Update on 802.1 Maintenance Request 193

802.1 Maintenance Request 193

Insert a new Figure 12-6, titled "Points in time for scheduled traffic":

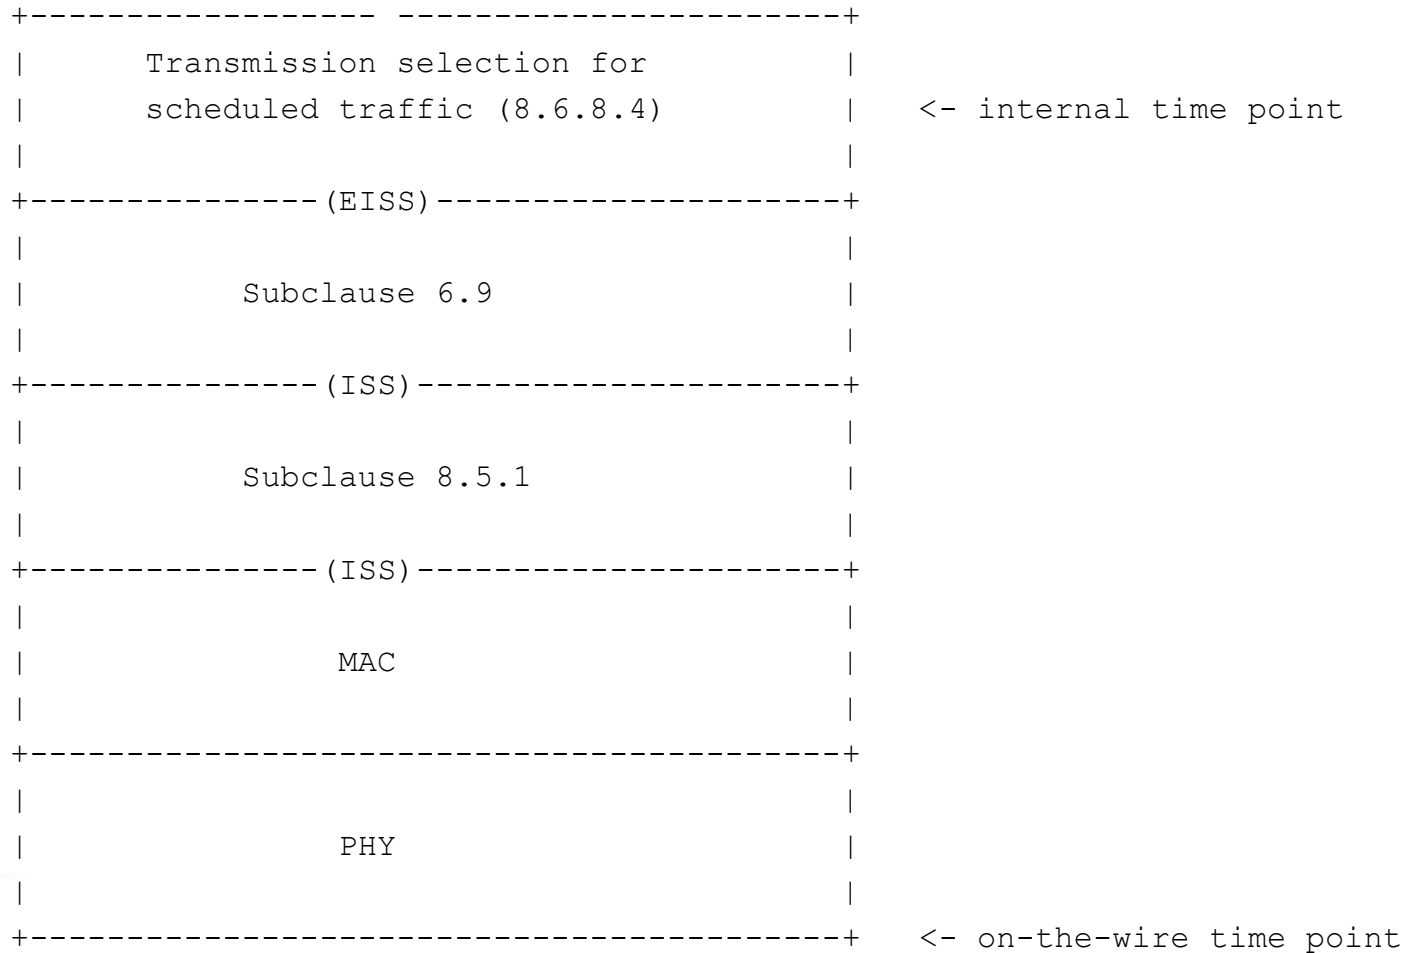
Figure 12-6 shows two points in time for scheduled traffic. The time of gate open/close described in subclause 8.6.8.4 is used for transmission selection, and that point in time exists internal to the Bridge (i.e. above MAC and PHY). A delay exists between this internal time point and the time of transmit on-the-wire. For example, if transition of a gate from closed to open immediately results in selection of a frame for transmission, there will be a delay from that internal time of transmission selection to the start of the frame on-the-wire. The internal time point will have variance (min/max), and the delay to the on-the-wire time point will also have variance.
